Subject: Duke Energy Carolinas, LLC
Oconee Nuclear Station, Units 1, 2, and 3
Docket Numbers 50-269, 50-270, and 50-287,
Renewed Operating Licenses DPR-38, DPR-47, and DPR-55
Licensing Basis for the Protected Service Water System - Responses to
Request for Additional Information

Responses to RAI Items

1XK & 2XK MCC.tcc Ref. Voltage: 600V Current in Amps x 10

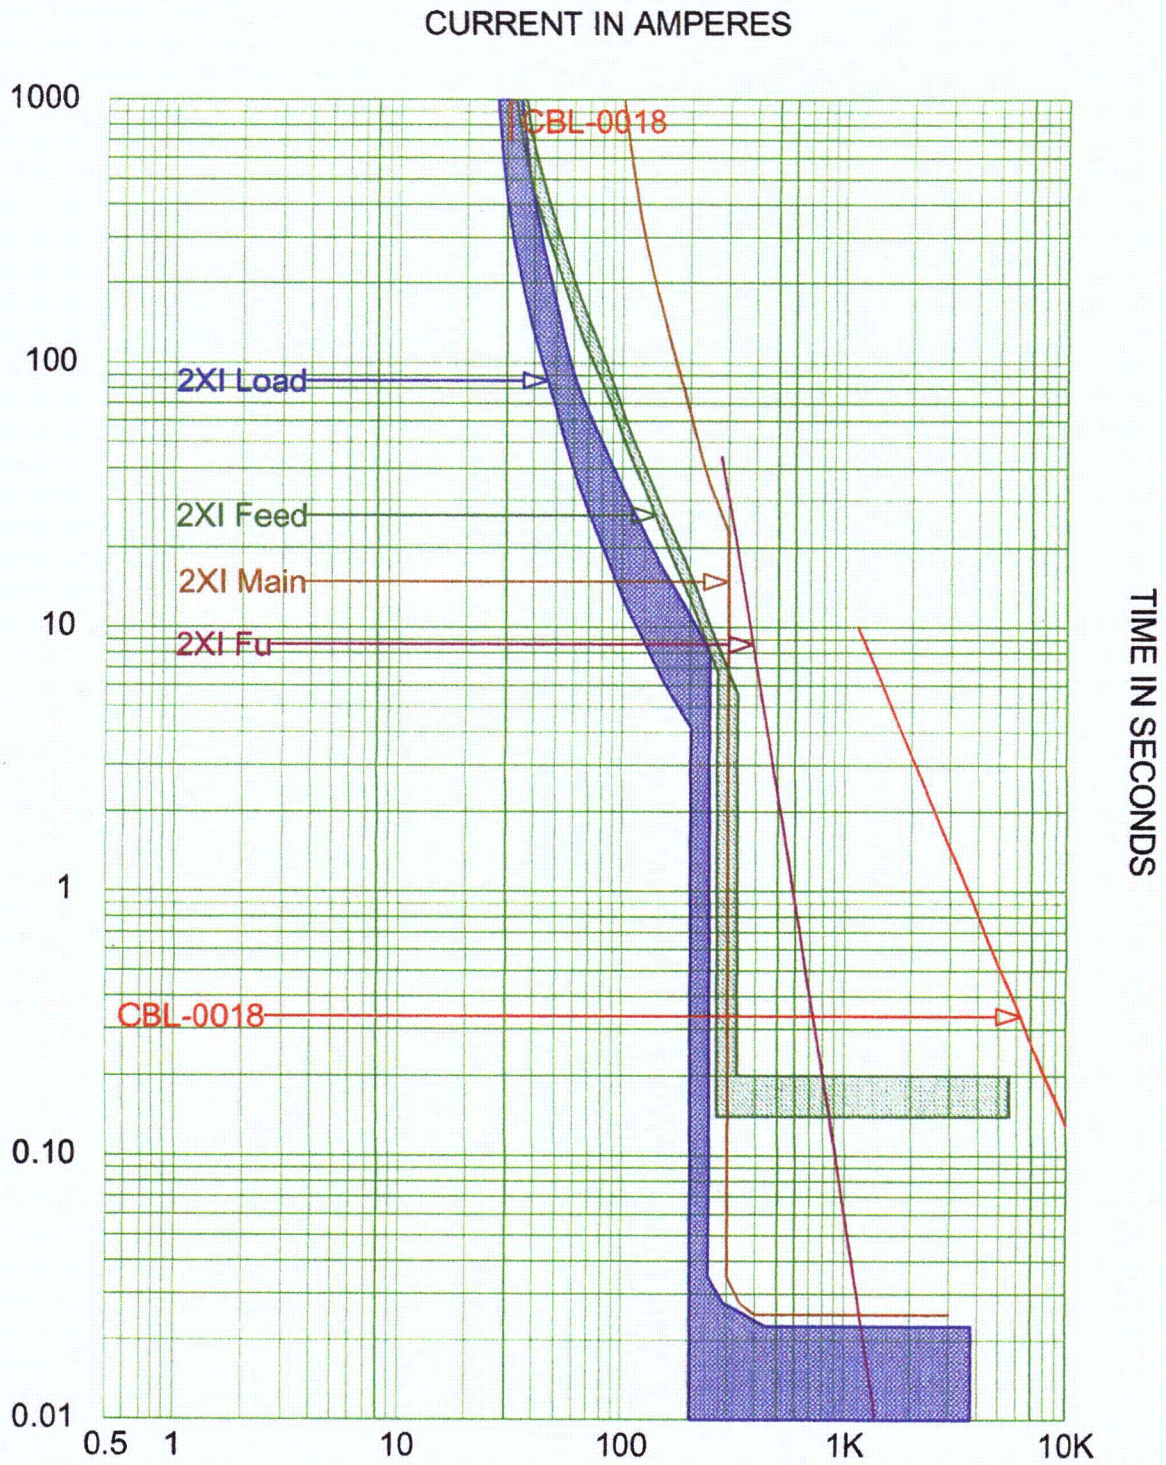
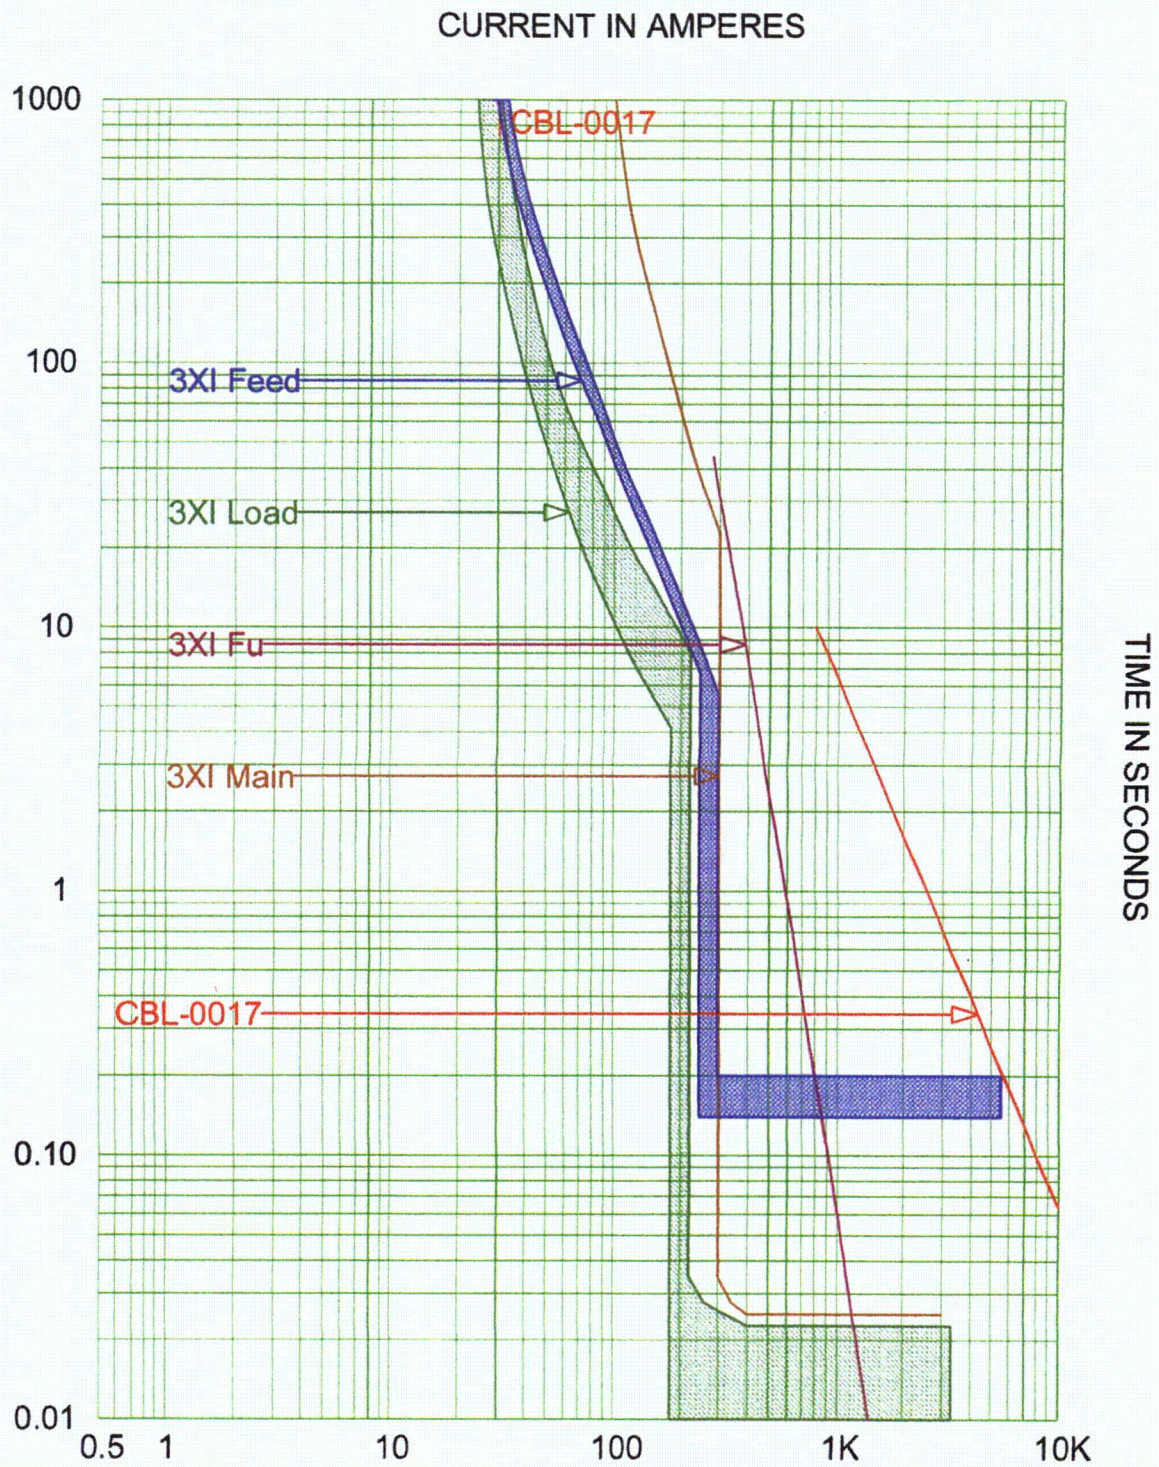
- Discuss in detail the overcurrent relay and breaker coordination for the PSW 600 V AC MCC 1XKMCC demonstrating adequate coordination between the upstream and the downstream relay and breakers.

- The MCC feeder cable for 1XK MCC consists of 3/C 500 kcmil cable. The optimal ampacity according to the ETAP analysis for this feed is 280A. MCC 1XK loading is 168kW. There is no MCC Main Breaker. The largest load breaker is a 200A, type TFJ breaker. The load center feeder breaker pickup is set to $0.625 \times (250A \text{ primary})$ to provide overload protection to the cable. The other settings are set to coordinate with the largest load breaker on the MCC. The coordination and the protection provided by the phase elements are illustrated on page 3 of 8 of Attachment 1 for RAI #129. Breaker pickup is less than cable ampacity above 1000 seconds as shown on the vendor trip curve (Refer to page 8 of 8 in Attachment 1 for RAI #129).

Figure 15

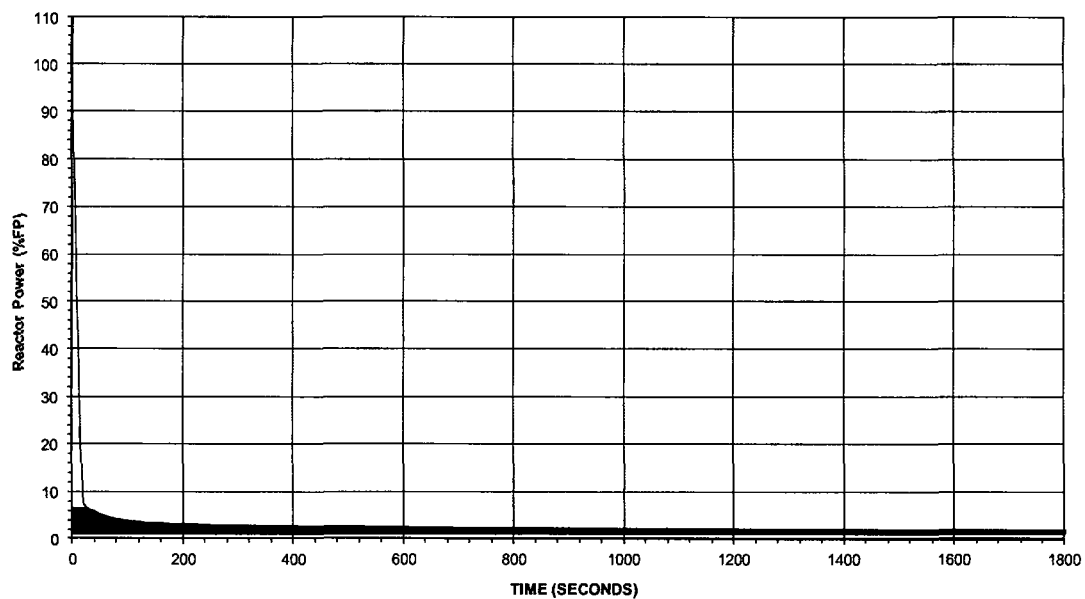
After the reactor trips, reactor power (Figure 15) rapidly decreases to typical post-trip decay heat levels, and drops below 1% of its full power level by the end of the transient. After SSF-ASW flow is established, decay heat is removed by the SGs for the remainder of the transient.

Figure 16

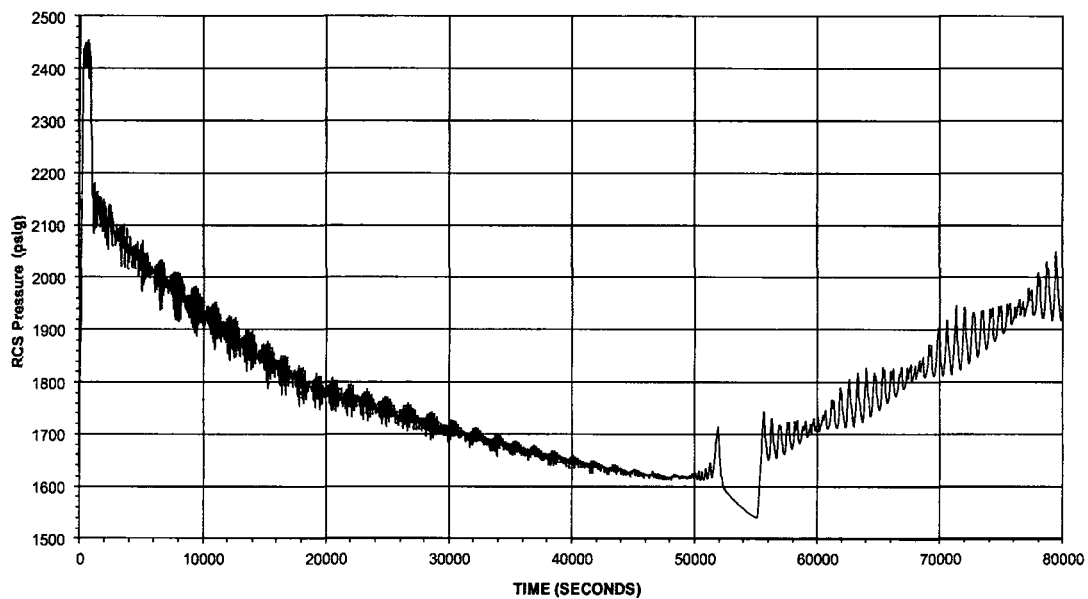
Figures 16 and 17 show the RCS pressure response for this case. Following reactor trip and the normal post-trip shrinkage and depressurization seen in the primary system, RCS pressure begins to rapidly increase as all secondary inventory is boiled off. The pressurizer PORV begins cycling in approximately 6 minutes, and continues to do so until SSF-ASW flow begins entering the SGs at 900 seconds. Following the initiation of SSF-ASW flow, RCS pressure decreases as the RCS is cooled down to a typical post-trip condition. Operators have been instructed to return the RCS to a nominal post-trip condition while attempting to maintain a relatively steady RCS pressure and pressurizer level using SSF-ASW. Due to the limited makeup capacity of the SSF RC makeup pump, this results in a very slow cooldown rate. To make this a bounding analysis with respect to subcooling margin, a more rapid cooldown of 4°F/hr was simulated. This results in some volumetric shrinkage and RCS depressurization. By the time the cooldown is terminated (~ 52000 seconds), RCS pressure has decreased to ~ 1600 psig. At this time, operators could open the SSF letdown line. Since RCS pressure is so low in this simulation at this point in time, this action is not modeled. This results in a small mass addition to the RCS, which results in a gradual repressurization. This continues to the end of the simulation.

Figure 17

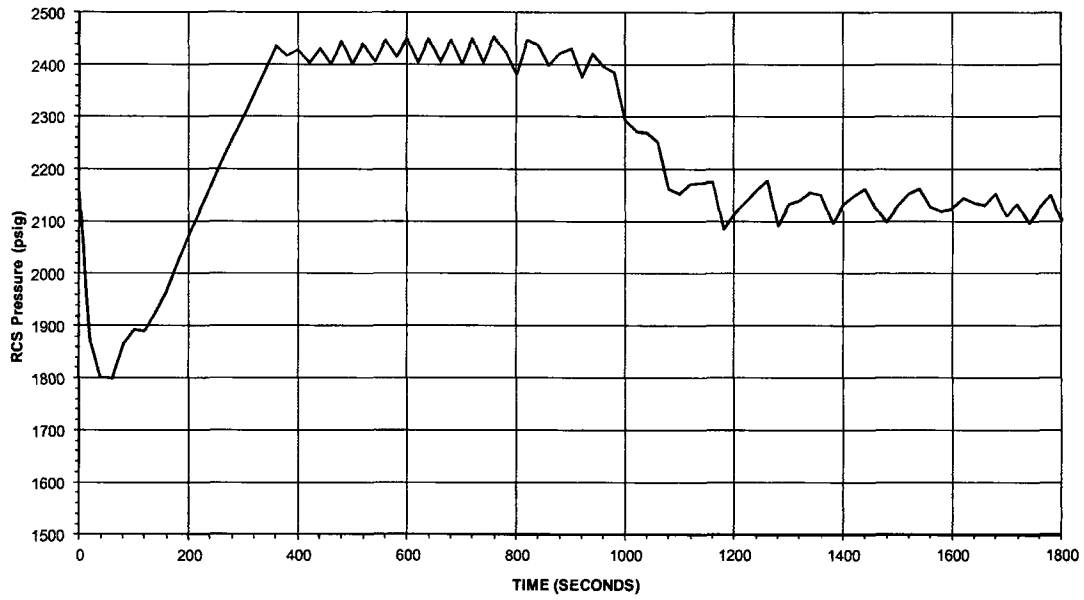
The results shown in Figure 17 demonstrate that peak RCS pressure would be maintained below 2750 psig, with margins in excess of 250 psig. Although the pressurizer PORV is modeled in this analysis, this conclusion would remain applicable, even if the pressurizer PORV was not modeled, as the pressurizer safety valves would open to relieve RCS pressure. The PSVs have a higher relief flow capacity than the PORV, per Section 2.1.2.6 of DPC-NE-3000-PA. The PSV opening setpoint is 2500 psig, versus 2450 psig for the PORV. This difference is well within the peak pressure margins shown in Figure 17.

Figure 18

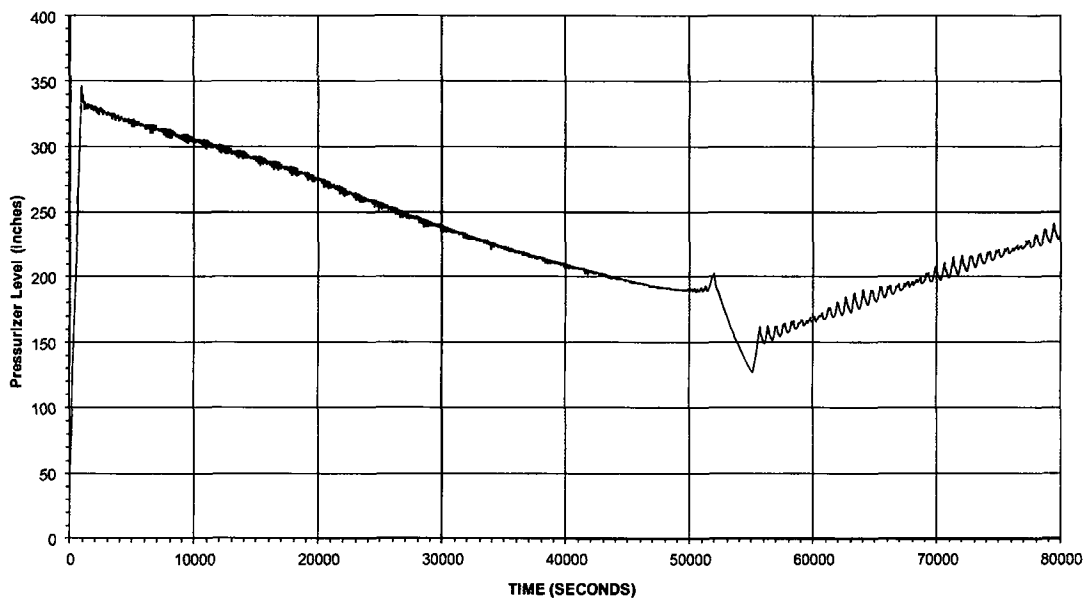
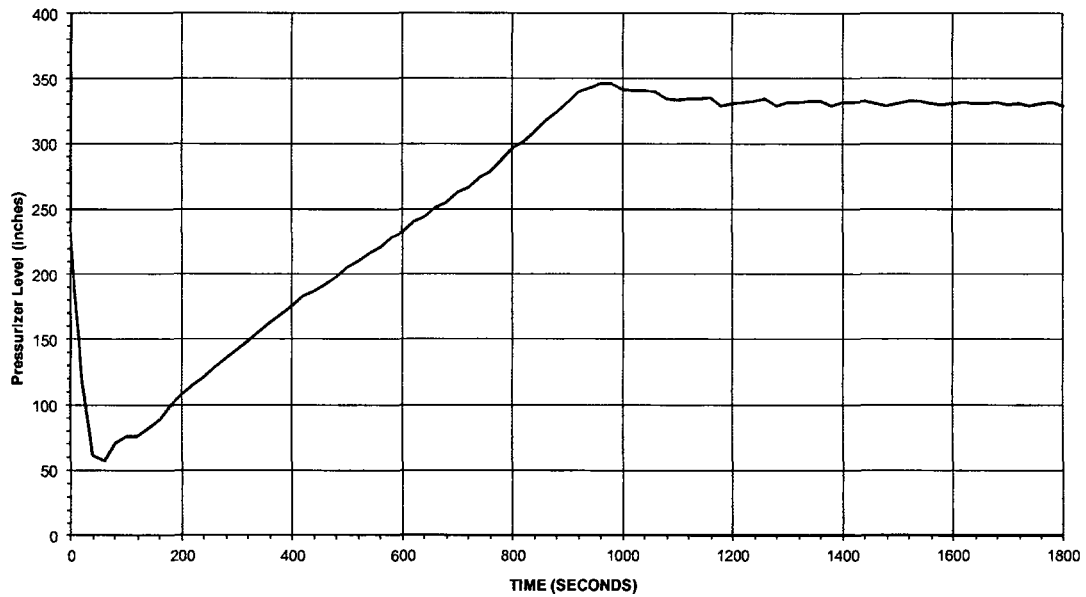
Pressurizer level (Figures 18 and 19) initially decreases following reactor trip due to post-trip shrinkage, then rapidly increases as the RCS heats up from the loss of all feedwater. After operators start the SSF support systems, level steadily decreases to ~ 175 inches by the time the cooldown is complete. As discussed before, operators would actually maintain pressurizer level approximately constant during the cooldown by reducing the cooldown rate. Again, this simulation assumes a more rapid cooldown rate to provide a bounding analysis. After the cooldown is complete, level steadily increases as the SSF RC makeup pump continues to provide mass addition to the RCS.

Figure 26

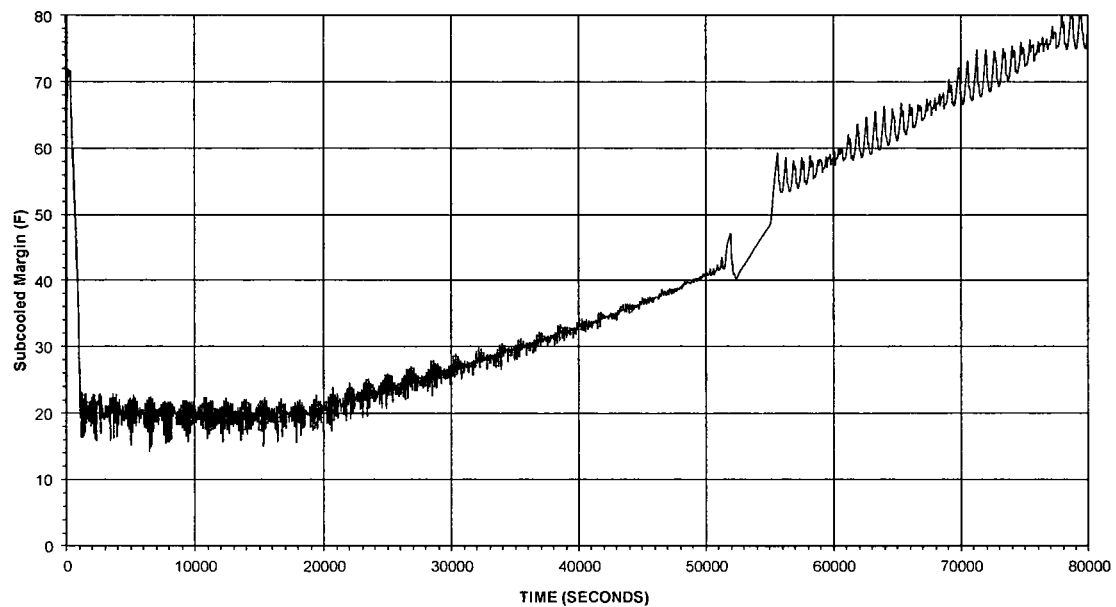
Figure 26 shows the RCS subcooled margin as a function of time. The minimum subcooled margin seen during this simulation is $\sim 20^{\circ}\text{F}$, which indicates that no voiding occurred in the RCS.

Figure 27

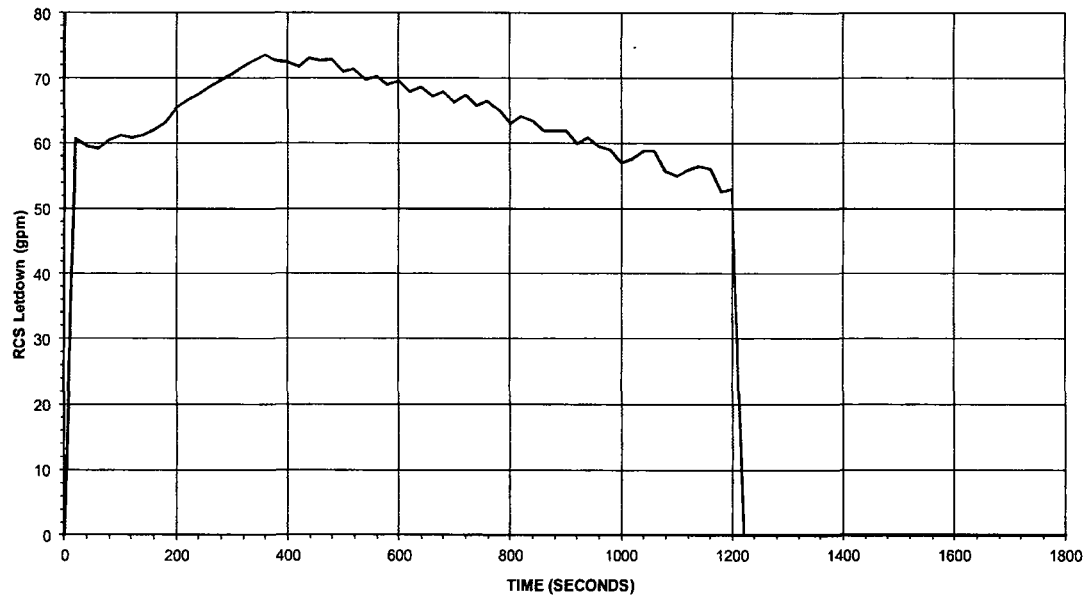
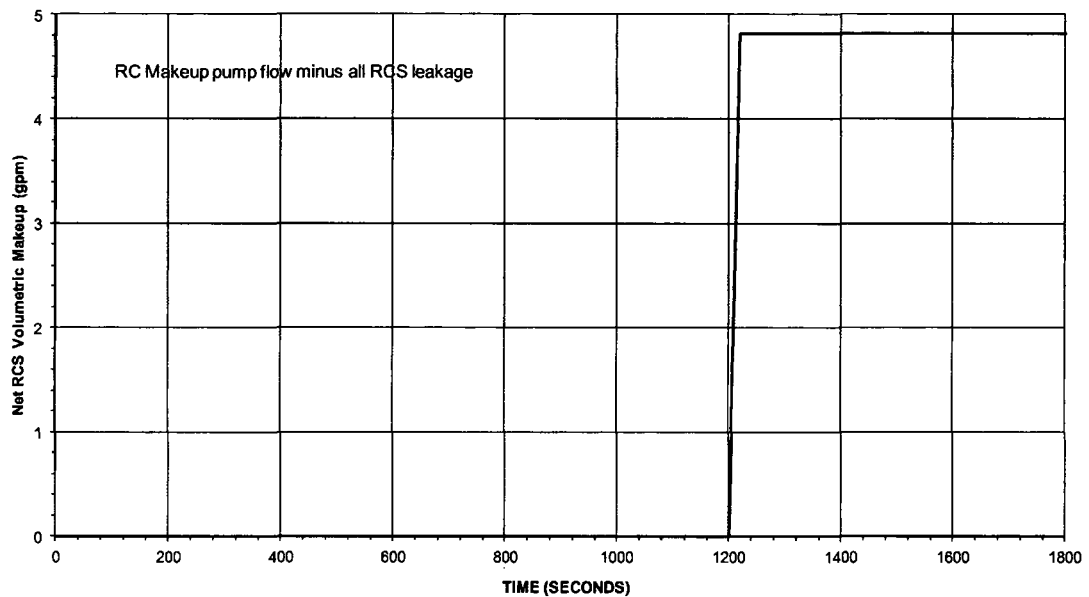
RCS letdown (Figure 27) is initially at ~ 70 gpm, then varies with RCS pressure until operators isolate it at 1200 seconds (20 minutes). It is assumed that operators start the SSF RC makeup pump (Figure 28) at 1200 seconds, at which time the RCP seal return block valves are isolated. Since the SSF RC makeup pump is a positive displacement pump, a constant flow over all RCS pressures is seen.

Figure 31

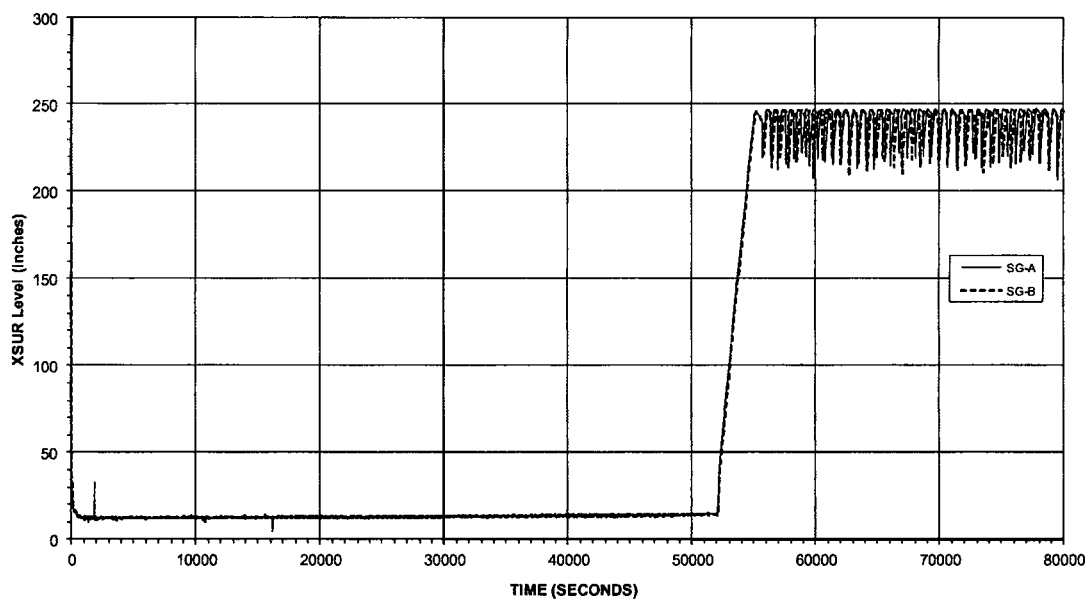
SG levels (Figure 31) rapidly decrease after the loss of all feedwater. By the time SSF-ASW flow begins at 900 seconds, the SGs have almost reached a dry condition. During the cooldown to a normal post-trip condition, all of the SSF ASW flow boils off until RCS temperatures decrease to within a few degrees of the SG saturation temperature. It can be seen in Figures 32 and 33 that a SSF-ASW flowrate of ~ 75 gpm/SG is required to maintain the cooldown rate assumed in this analysis ($\sim 4^{\circ}\text{F}$). After this condition is achieved at $\sim 52,000$ seconds, SG levels are then increased up to their typical natural circulation level of ~ 240 inches.
